**Subject** ▶ Change on method of attaching Angular Guide

**For Models** ▶ 5091DZ,5091DWH,5091DWG,5092D,5092DW,4191DZ,4191DWA (Cordless Circular Saws and Cordless Cutters)

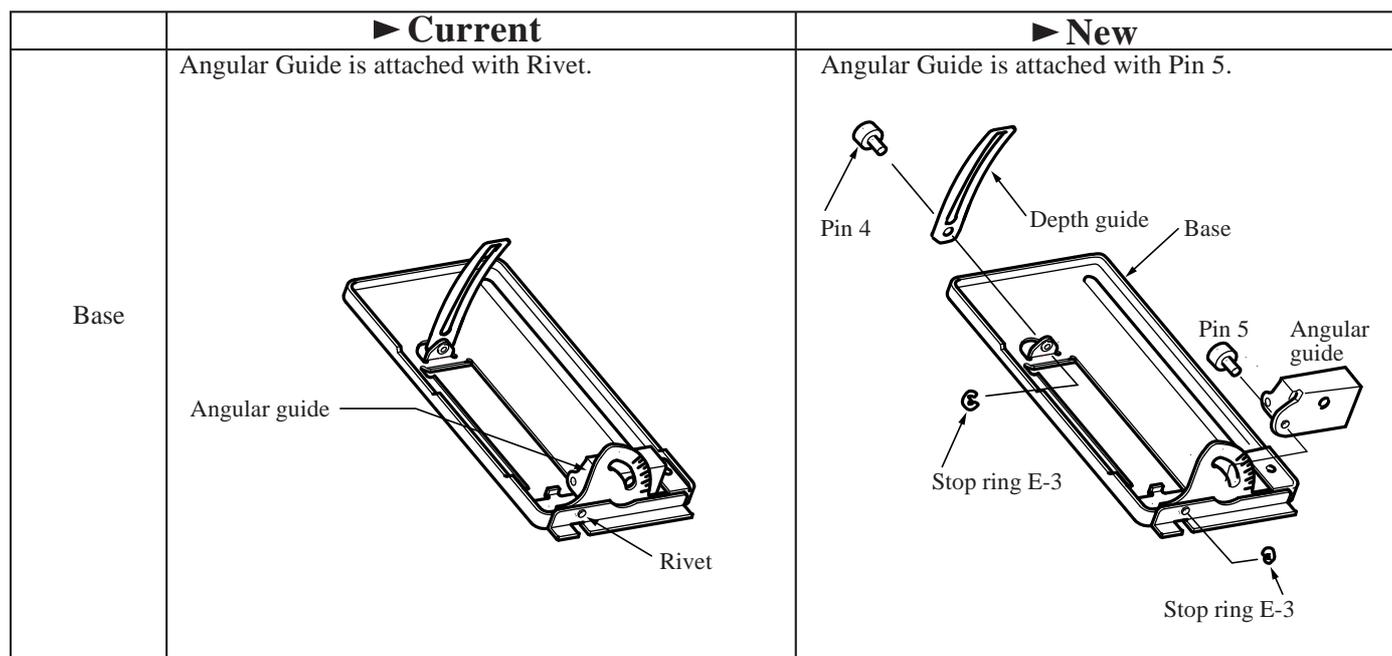
**Description** ▶ As illustrated below, method of attaching Angular Guide to Base has been changed from by rivet to by Pin and Stop Ring to make attaching and/or detaching easier.
